Byron Station, Units 1 and 2
Facility Operating License Nos. NPF-37 and NPF-66
NRC Docket Nos. STN 50-454 and STN 50-455

Subject: Second Six-Month Status Report in Response to March 12, 2012 Commission Order Modifying Licenses with Regard to Requirements for Mitigation Strategies for Beyond-Design-Basis External Events (Order Number EA-12-049)

**Second Six-Month Status Report for the Implementation of Order EA-12-049, Order
Modifying Licenses with Regard to Requirements for Mitigation Strategies for Beyond-
Design-Basis External Events**

Updated Mechanical One Line Diagrams

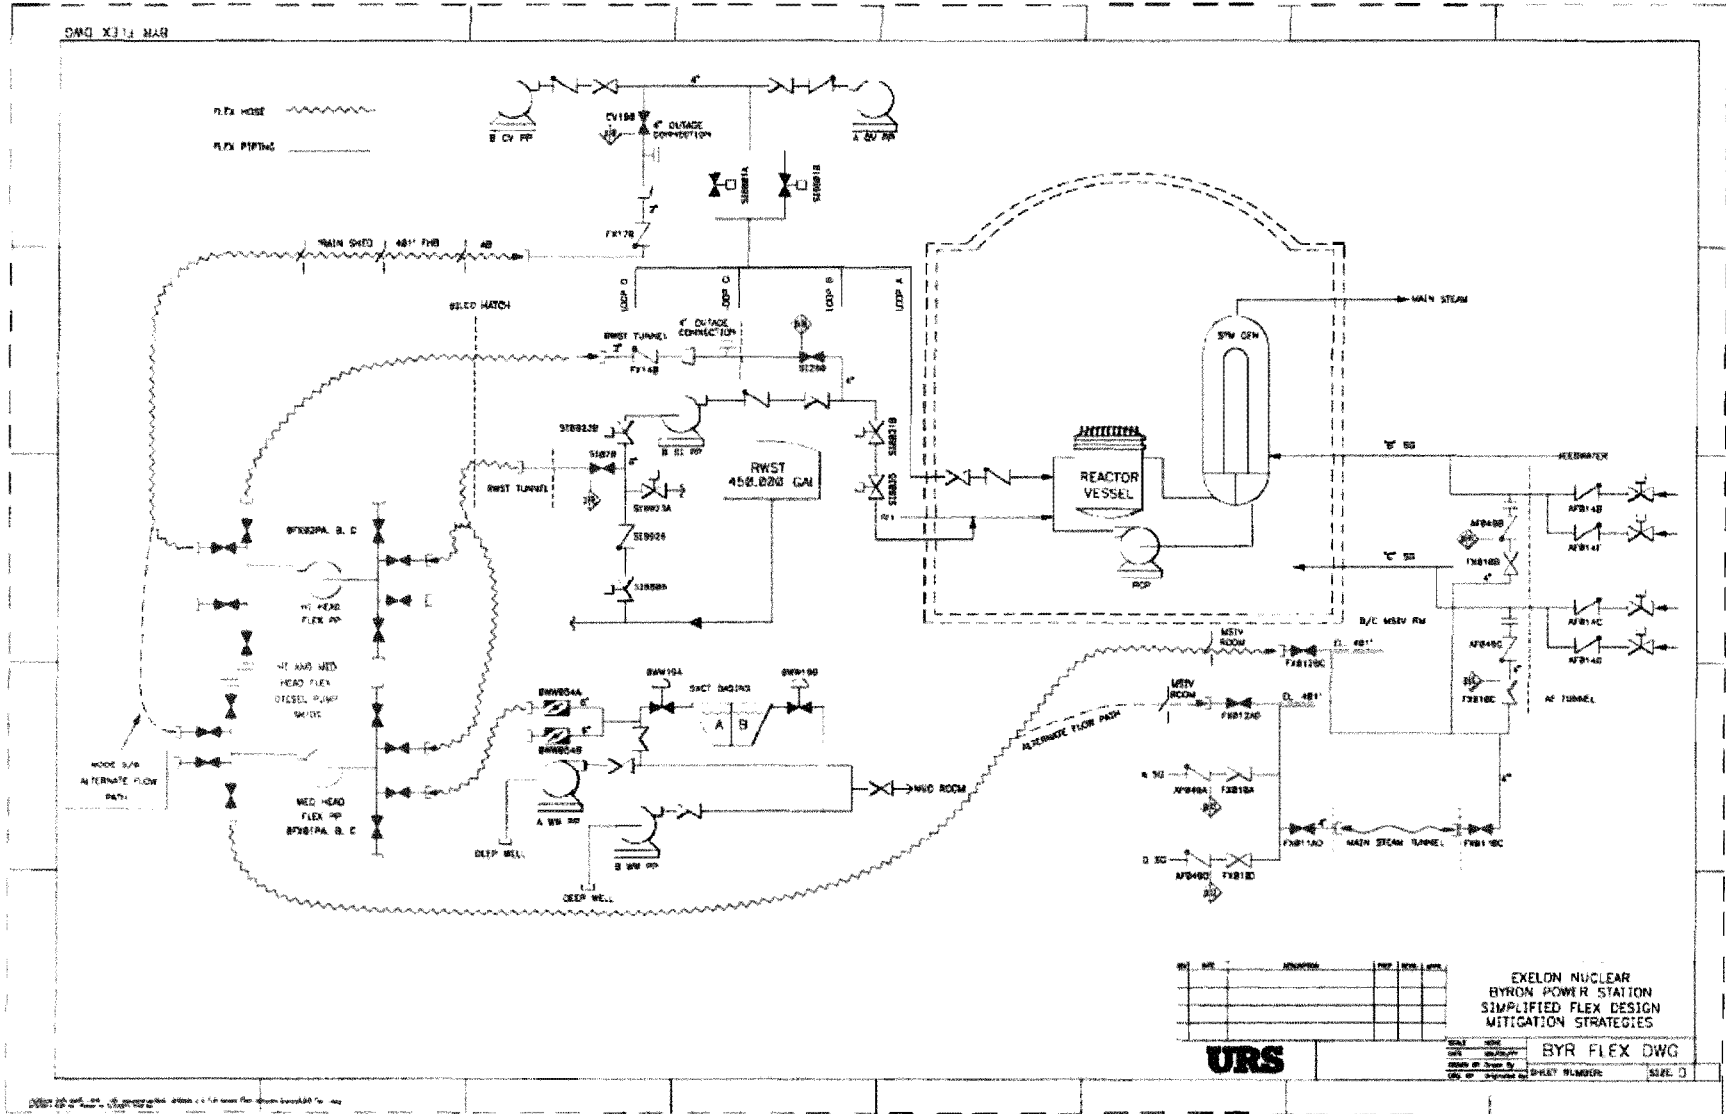
Section: Attachment 3 Conceptual Sketches

Reason for Change: Modification design details were refined as part of the standardized modification design process resulting in changes to the mechanical conceptual sketches.

Change: Current mechanical conceptual sketches are attached to this document. See Attachment 3.
